From: "Fickas, Justin" <JDFICKAS@mactec.com>
To: Purva.Prabhu@dnr.state.ga.us; Furqan.Shaikh@dnr.state.ga.us
CC: James.Capp@dnr.state.ga.us
Date: 1/18/2010 11:25 AM
Subject: Plant Washington Air Permit Comments
Attachments: H2SO4 Comments.DOC; NOx Comments.DOC; Plant Washington IGCC Analysis.DOC;
P
M2 5 Comments.DOC; PM Comments.DOC; SO2 Comments.DOC; VOC
Comments.DOC

The attached material has been developed at the request of our client, Power4Georgians (P4G). The attached documents relate to information that cover responses to comments received by EPD regarding the draft air permit. To the extent that the data included in this response to comments represents new or updated information, please consider this submission an addendum to the original application.

GreenLaw H₂SO₄ Comments – Section I Page 20-22:

Figure 13 Pre- and post-retrofit NO_x vs. load, R.W. Scherer Unit 4.

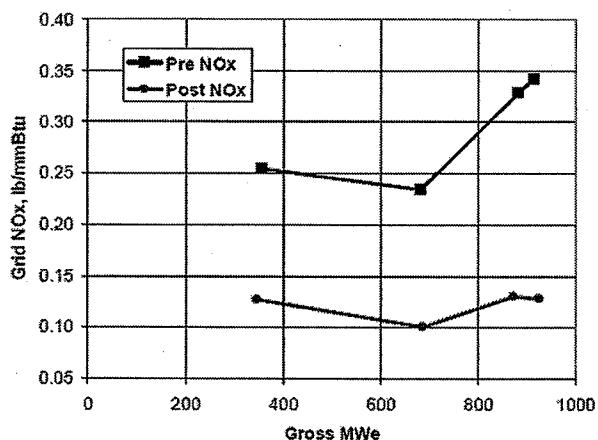
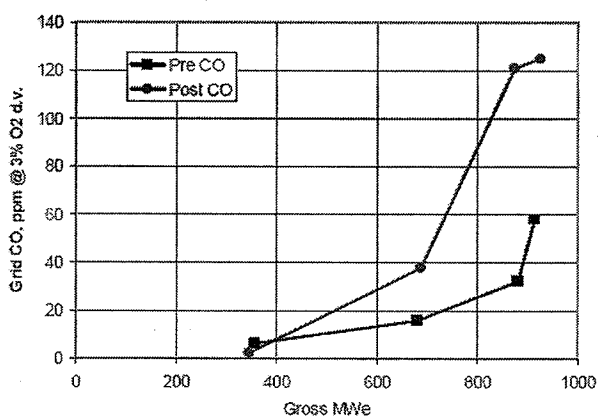
Comment: T. Whitfield, et al., *Comparison of NOx Emissions Reductions with PRB and Bituminous Coals in 900 MW Tangentially Fired Boilers, 2003 Mega Symposium, Ex. 133. (Ex 133)*

Response: No direct quotations from this document are provided by Commenters regarding lower achievable NOx emission levels. A review of this document indicates that the reference is a detailed technical paper discussing the results of the NOx emission reduction strategies employed at Georgia Power Plant Scherer. Exhibit 133 is essentially the technical companion piece to the same Plant Scherer study summarized in Exhibit 130. Exhibit 133, as with Exhibit 130, clearly demonstrate the inverse relationship that exists between NOx and CO emission levels in the boiler: *i.e.*, as NOx emission levels for Scherer Units 3 and 4 decreased during the study, CO emission levels from those same two units increased. The following Figure 13 and 14 from Exhibit 133 clearly shows Scherer Unit 4 CO emissions increasing as boiler outlet NOx levels decrease during retrofit activities.
